SERVICE BULLETIN CHANGE NOTICE

S.B. No. A320-21-1019 REV.
Mod. No. 20327/P01104

TITLE : AIR CONDITIONING - COCKPIT - REPLACE AIR DUCT.

SERVICE BULLETIN No. : A320-21-1019

**Installation of New Silenced Duct
Figure 1**

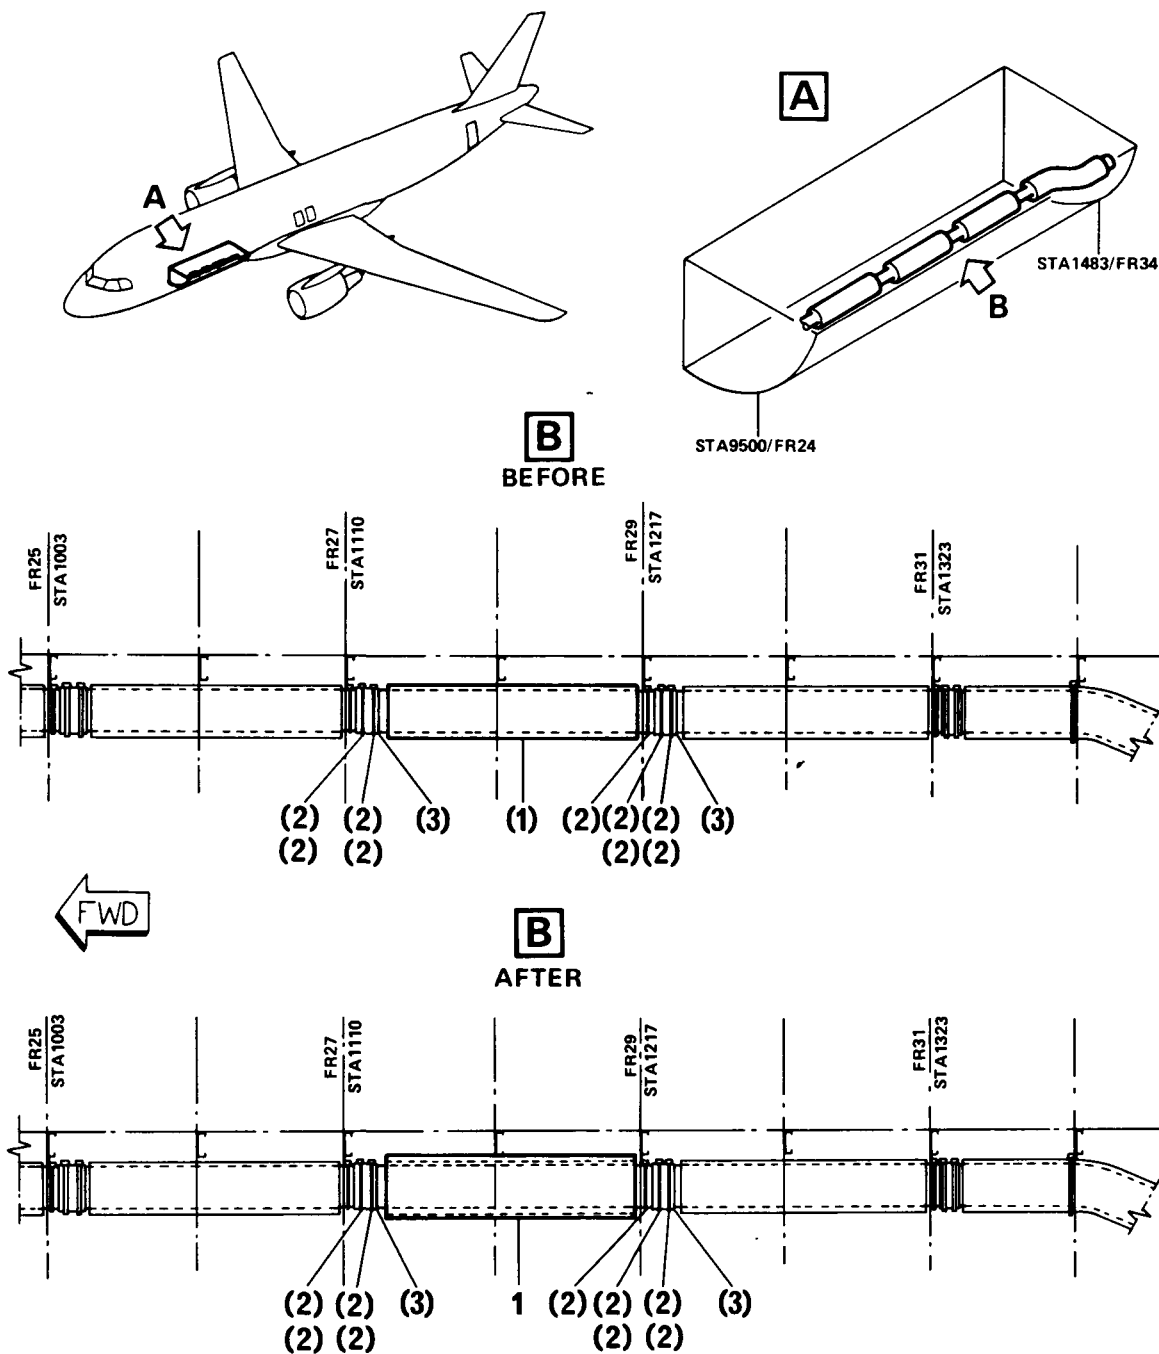
- (1) Remove the left lateral panel 131HW between the frames 27 to 30
(re-used)
- (2) Remove the basic air conditioning duct that is in the aircraft

9 clamps	Item (2)	(retain)
2 sleeves	Item (3)	(retain)
1 duct	Item (1)	(Ref. NOTE)

- (3) Install the new silenced duct

1 duct D2121097000000	Item 1	
2 sleeves	Item (3)	(retained at removal)
9 clamps	Item (2)	(retained at removal)
